# NEWMAR CORPORATION WARRANTY DEPARTMENT

## RECALL SERVICE BULLETIN

DATE ISSUED	MODEL YEAR(S) AFFECTED	RSB #
12/01/2016	2017	474

Spartan Motors USA, Inc. has decided that a defect relating to motor vehicle safety exists in specific motor homes built on Spartan chassis. In response, Newmar Corporation is publishing a recall:  
NHTSA #16V 810 TC #2016-543.

**FIG. 3-2**

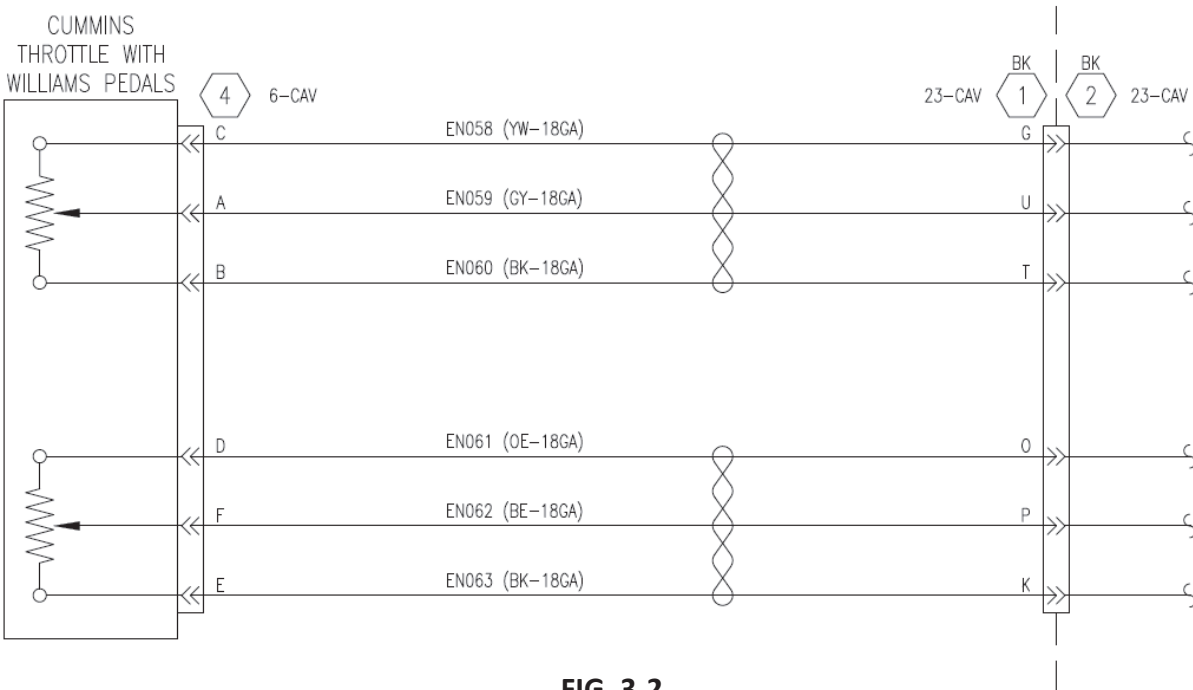
**CONDITION:** Certain wires in the throttle circuit were not twisted which could result in a throttle setting above or below the commanded throttle setting/input.

1. Identify and disconnect throttle pedal connector, Item ④ in FIG. 3-2, from throttle assembly. Pull back loom 12 inches over wiring terminated into throttle pedal connector. Verify wiring consists of 6 discreet wires (untwisted) then go to step 2. If wiring consists of 2 twisted triplets (refer to FIG. 3-2), replace loom over wiring and reconnect throttle pedal connector, Item ④. No further action is required.

2. Pull back existing throttle pedal connector and stow/tape it back onto existing harness.
3. Connect new throttle pedal connector, Item ④, of new 3995-GG5-001 overlay harness into throttle assembly. Refer to FIG. 3-2.

5. Locate and disconnect main chassis harness interconnect, Item ①, from forward electrical compartment disconnect. Refer to FIG. 3-2
6. Using Deutsch contact removal tool, remove circuits from disconnected Item ①, cavities O, P, K, G, U, and T. Refer to FIG. 3-1.

**CORRECTION:** Adding an overlay harness with properly twisted wiring.

- Cut off contacts from removed circuits, individually heat shrink, and pull/tape back onto existing harness.
- Insert new circuits from new overlay harness into existing main chassis harness interconnect connector Item 1. Refer to FIG. 3-1. Each wire is tagged with a label depicting which cavity it belongs in. Refer to FIG. 3-2. Note that the wiring/pin out does not change.

9. Re-connect main chassis harness interconnect connector, Item , to firewall disconnect. Refer to FIG. 3-2.
10. Assure new overlay harness is secured to existing harness as required throughout its entire run. Tape back any extra length as required.
11. Using Cummins® INSITE™, verify that no fault codes are generated at key-up. Also verify that appropriate values are seen in regards to throttle pedal position.

**FIG. 6-1**

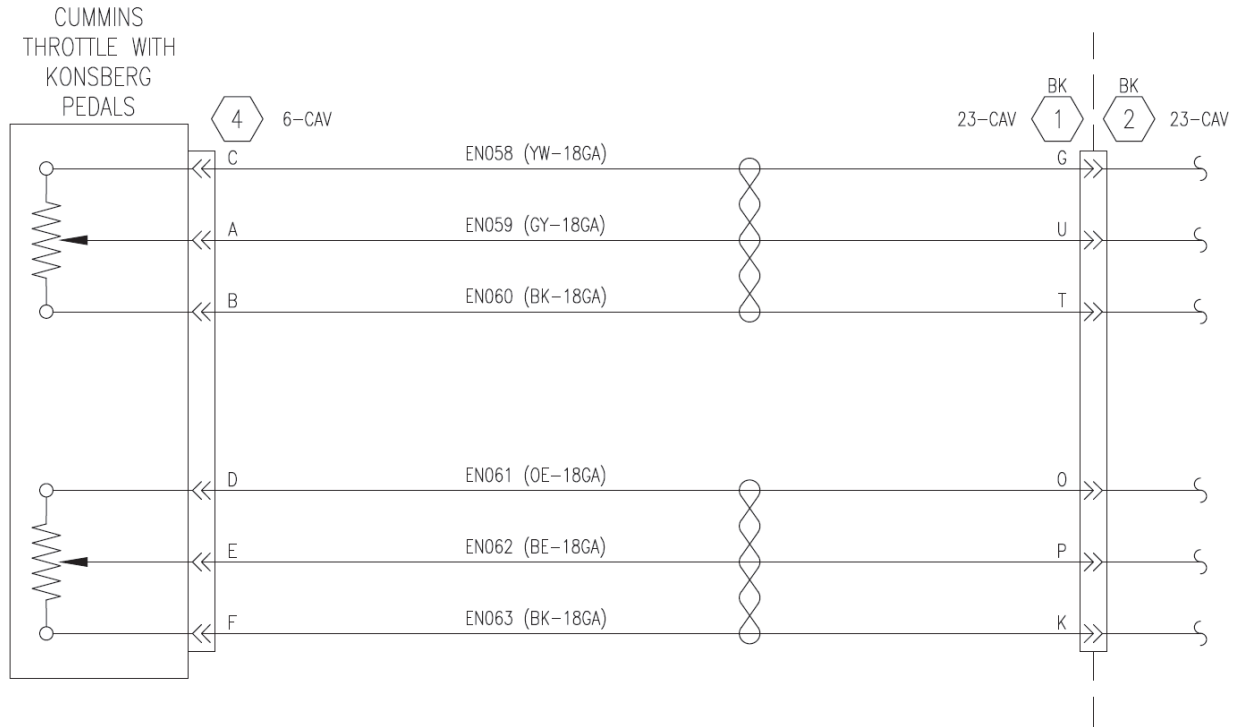
1. Identify and disconnect throttle pedal connector, Item **④** in FIG 6-1, from throttle assembly. Pull back loom 12 inches over wiring terminated into throttle pedal connector. Verify wiring consists of 6 discreet wires (untwisted) then go to step 2. If wiring consists of 2 twisted triplets (refer to FIG. 6-1), replace loom over wiring and reconnect throttle pedal connector, Item **④**. No further action is required.

2. Pull back existing throttle pedal connector and stow/tape it back onto existing harness.
3. Connect new throttle pedal connector, Item **④** , of new 3995-GG5-002 overlay harness into throttle assembly. Refer to FIG. 6-1.

4. Route and secure as necessary new 3995-GG5-002 overlay harness along existing harness to firewall disconnect located forward of driver's position.
5. Locate and disconnect main chassis harness interconnect, Item **①** , from firewall disconnect. Refer to FIG. 6-1.

- Insert new circuits from new overlay harness into existing main chassis harness interconnect connector Item **1** . Refer to FIG. 5-1. Each wire is tagged with a label depicting which cavity it belongs in. Refer to FIG. 6-1. Note that the wiring/pin out does not change.

- Re-connect main chassis harness interconnect connector, Item **1** , to firewall disconnect. Refer to FIG. 6-1.
- Assure new overlay harness is secured to existing harness as required throughout its entire run. Tape back any extra length as required.
- Using Cummins® INSITE™, verify that no fault codes are generated at key-up. Also verify that appropriate values are seen in regards to throttle pedal position.

**FIG. 8-1**

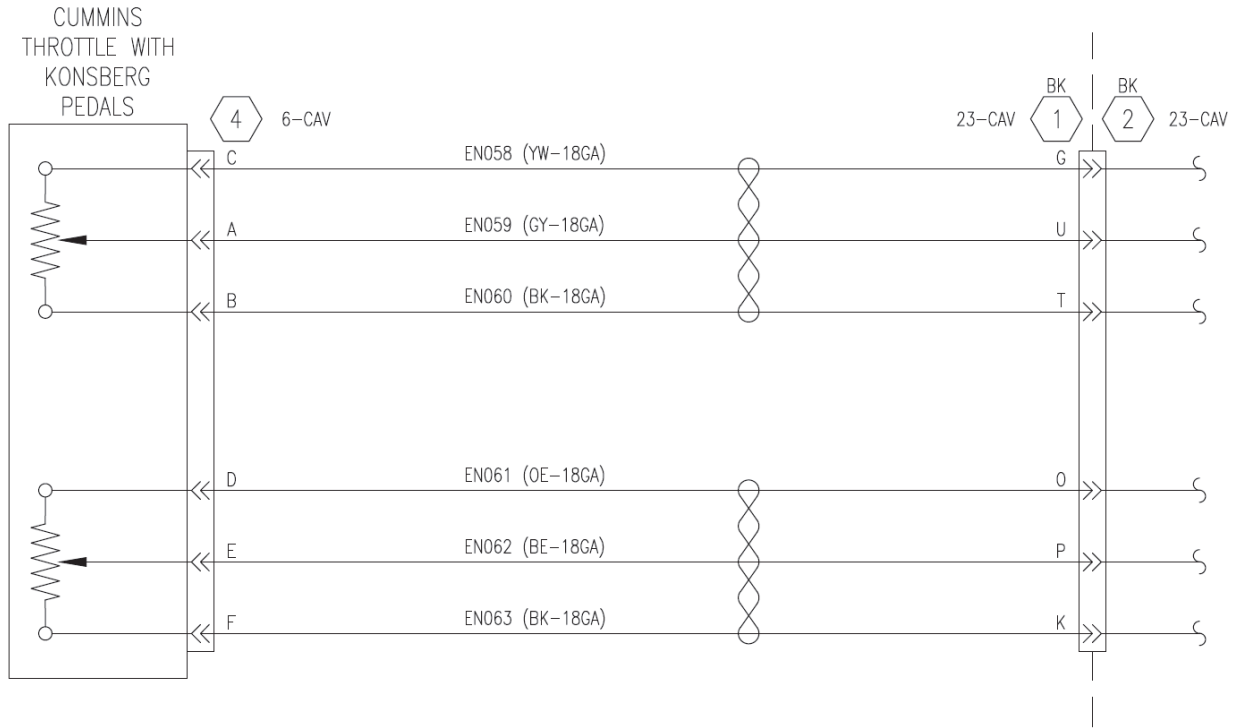
1. Identify and disconnect throttle pedal connector, Item ④ in FIG. 8-1, from throttle assembly. Pull back loom 12 inches over wiring terminated into throttle pedal connector. Verify wiring consists of 6 discreet wires (untwisted) then go to step 2. If wiring consists of 2 twisted triplets (refer to FIG. 8-1), replace loom over wiring and reconnect throttle pedal connector, Item ④. No further action is required.

2. Pull back existing throttle pedal connector and stow/tape it back onto existing harness.
3. Connect new throttle pedal connector, Item ④, of new 3995-GG5-002 overlay harness into throttle assembly. Refer to FIG. 8-1.

5. Locate and disconnect main chassis harness interconnect, Item ①, from forward electrical compartment disconnect. Refer to FIG. 8-1.
6. Using Deutsch contact removal tool, remove circuits from disconnected Item ① cavities O, P, K, G, U, and T. Refer to FIG. 7-1.

- Insert new circuits from new overlay harness into existing main chassis harness interconnect connector Item **1** . Refer to FIG. 7-1. Each wire is tagged with a label depicting which cavity it belongs in. Refer to FIG. 8-1. Note that the wiring/pin out does not change.

- Re-connect main chassis harness interconnect connector, Item **1** , to forward electrical compartment disconnect. Refer to FIG. 8-1.
- Assure new overlay harness is secured to existing harness as required throughout its entire run. Tape back any extra length as required.
- Using Cummins® INSITE™, verify that no fault codes are generated at key-up. Also verify that appropriate values are seen in regards to throttle pedal position.
